2nd Further Information

Proposed Temporary Open Storage of Vehicles with Ancillary Facilities for a Period of 3 Years and Associated Filling of Land in "Agriculture" Zone, Lots 933 S.A and 934 in D.D. 115 and Various Lots in D.D. 116 and Adjoining Government Land, Au Tau, Yuen Long, New Territories

(S.16 Planning Application No. A/YL-TT/663)

Responses-to-Comments

PLAN 1 001

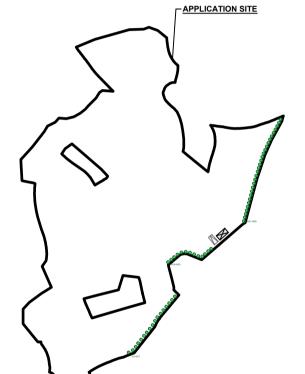
(a) The applicant should provide the broadbrush tree survey, mitigation measures and landscape proposal to demonstrate that the proposed uses would not have adverse landscape impact on the Site and surrounding areas. The site inspection conducted on 26.11.2024 identified 59 existing trees within the Site. All trees identified thereon are of common species. The tree survey report is enclosed at **Annex 1a.** The existing trees are proposed to be felled as they are in conflict with the proposed development scheme. In order to mitigate the potential landscape impact that would have arisen from the proposed development, the applicant proposes to plant 59 new trees of local species, i.e. *Bauhinia x blakeana*, at the Site on a 1:1 ratio, with a view to compensating for the existing trees to be felled.

In view of the provision of new trees, the extend of the proposed filling of land and the area for open storage have been revised. The area of the proposed filling of land is reduced from 14,250 m^2 to 13,885 m^2 (about), whilst the area for open storage is reduced from 11,583 m^2 to 11,401 m^2 (about).

The landscape plan, the revised plan showing filling of land at the Site, the revised layout plan, and revised pages of Form No. S16-III and the Planning Statement are enclosed at **Annex 1b**.
